## SAFETY RECALL NOTICE

McLaren 600LT – Engine Radiator Upper Outboard Coolant Hoses Replacement

<b>Bulletin type:</b>	Safety Recall Campaign
<b>Reference number:</b>	N/A
<b>Campaign reference:</b>	SRC 13 L 001
<b>Attention:</b>	Retailer Aftersales Managers, Retailer Sales Managers, Retailer Marketing Managers, Retailer Service Managers, Retailer Service Advisors, Retailer Technicians, Retailer Parts Managers, Retailer General Managers, All Retailer Staff
<b>Affected vehicles:</b>	McLaren 600LT Coupe, McLaren 600LT Spider
<b>Situation:</b>	Replacement of engine radiator upper outboard coolant hoses, RH and LH bank
<b>Procedure:</b>	Action all affected vehicles. Please refer to the information outlined in this document to complete the required work
<b>Date:</b>	XX Month 2023

#### Urgent Safety Recall Campaign – McLaren 600LT Engine Radiator Upper Outboard Coolant Hoses Replacement

Image 1. Location of Upper Outboard Radiator Hoses, LH and RH bank

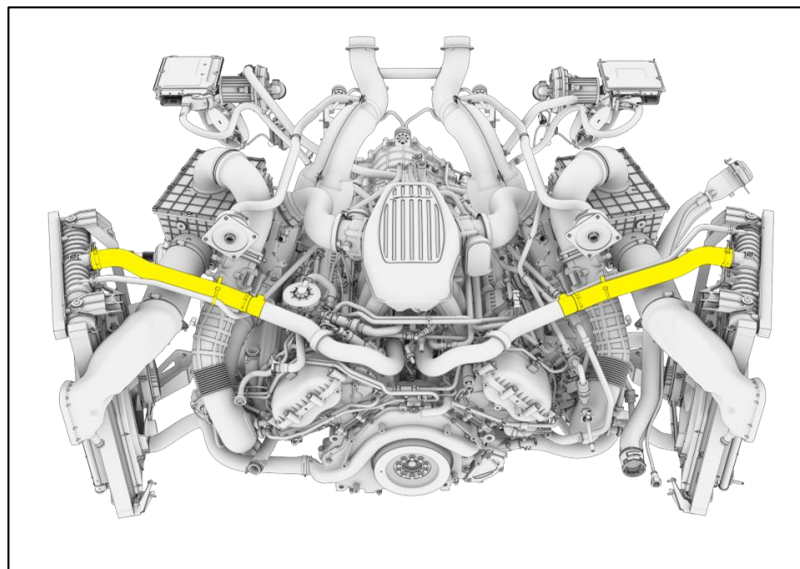
This voluntary safety recall relates to the risk of a potential coolant leak in the joint between the upper outboard radiator coolant hose and the temperature sensor housing - in particular during dynamic driving activities commonly associated with track running - due to inadequate sealing of the joint. The joint between the coolant hose and the temperature sensor housing is situated close to engine components which have a high operating temperature. If sufficient coolant is released in proximity to these components while at high operating temperature, it could result in thermal activity.

The below parts are required to action this rework and replace both engine radiator upper outboard hose assemblies RH bank and LH bank. All parts in the list below can be ordered in the usual way via Unidial 2.

The following components are not part of the recall; however, they are required to be replaced at the same time as part of the rework process. This is to ensure good fitment between the new plastic temperature sensor housing (contained with the outboard hoses) and the inboard coolant hoses – eliminating any effects that a deformation of the old hoses (as mated to a different housing) may have to the sealing of the joint.
